**Response to Comment Letter No. G1-86**

APPENDIX G1: RESPONSE TO COMMENTS

In addition, many sensitive sites are located in close proximity to this project as shown by the following map.

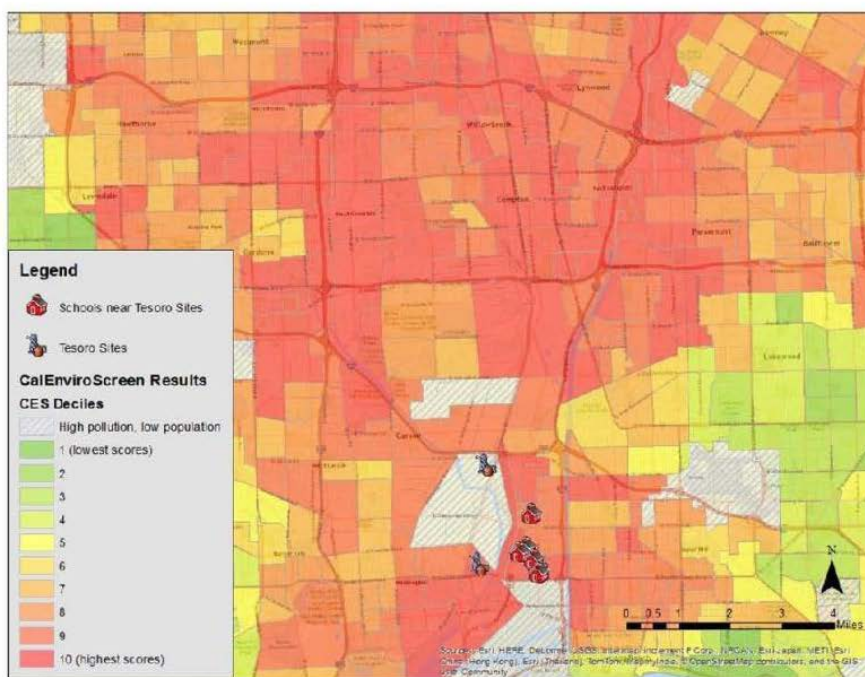
G1-86.3  
cont'd.

G1-86.3  
cont'd.

The DEIR contained a full analysis of all environmental impacts as required by CEQA. OEHHA has indicated that the CalEnviroScreen tool was not developed to address CEQA analyses or impacts.<sup>298</sup> CalEnviroScreen is not directly applicable to analysis of impacts in accordance with CEQA because it compares the relative burdens on communities but does not provide an absolute measure of those burdens. For this same reason, the tool is not a substitute for a formal risk assessment determining health impacts. While the DEIR is not required to analyze environmental justice impacts specifically, the DEIR analysis of localized air quality impacts addresses the environmental justice concerns raised by the comment. See Master Response 14 for additional information regarding environmental justice.

Question/Concern 20:

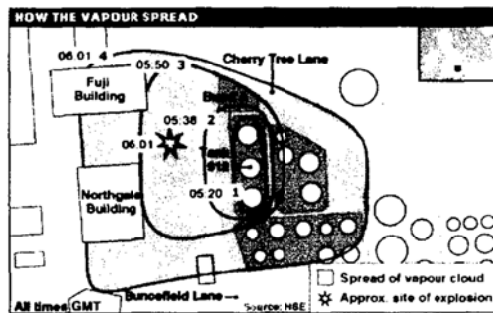
The Draft EIR Page C-26, Figure 4-6, identifies a "Vulnerability Zone for New 500,000 bbl. Storage Tanks", for the proposed group of 6 new such tanks, enabling storage of 3,000,000 bbl. of crude oil within a small spatial region. This Figure 4-6 "Vulnerability Zone" is only 5X larger than the geometric footprint of the tanks themselves. Citizen considers this Appendix C determination to be a potentially significant underestimate of the hazards and risks this tank group can present.

As an example, the vulnerability and subsequent explosion zone for the massive 12/11/2005 Buncefield UK Oil Storage Facility fire was determined to significantly exceed Appendix C value of 5X, as determined post-catastrophe, and summarized in the graphic below. This graphic shows >50X extent of the vulnerability zone, and highlights the need a further detailed study of the new 3,000,000 bbl. crude oil storage risk.

Question/Concern 20:

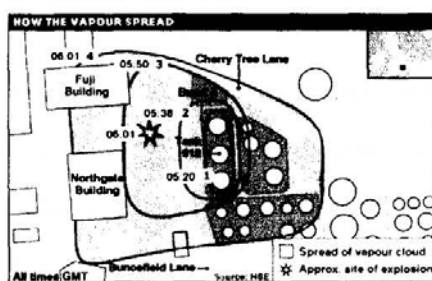
The Draft EIR Page C-26, Figure 4-6, identifies a "Vulnerability Zone for New 500,000 bbl. Storage Tanks", for the proposed group of 6 new such tanks, enabling storage of 3,000,000 bbl. of crude oil within a small spatial region. This Figure 4-6 "Vulnerability Zone" is only 5X larger than the geometric footprint of the tanks themselves. Citizen considers this Appendix C determination to be a potentially significant underestimate of the hazards and risks this tank group can present.

As an example, the vulnerability and subsequent explosion zone for the massive 12/11/2005 Buncefield UK Oil Storage Facility fire was determined to significantly exceed Appendix C value of 5X, as determined post-catastrophe, and summarized in the graphic below. This graphic shows >50X extent of the vulnerability zone, and highlights the need a further detailed study of the new 3,000,000 bbl. crude oil storage risk.

See Response G1-90.19 regarding the flash fire as being the worst-case consequence and the flash fire was not the only upset scenario analyzed. The DEIR fully analyzed the potential hazards of the proposed project in its entirety (see Table 4.3-2 and Figures 4.3-1 through 4.3-3 of the DEIR for all project components evaluated). As explained in Response G1-90.19, secondary effects of flash fires do not damage structures and metal objects within the vulnerability zone. For this reason secondary effects are not foreseeable and, therefore, are not evaluated. Similarly, secondary effects from other types of hazards are not expected (e.g., see Responses G1-78.226 and G1-78.227 for a discussion on vapor cloud explosions).
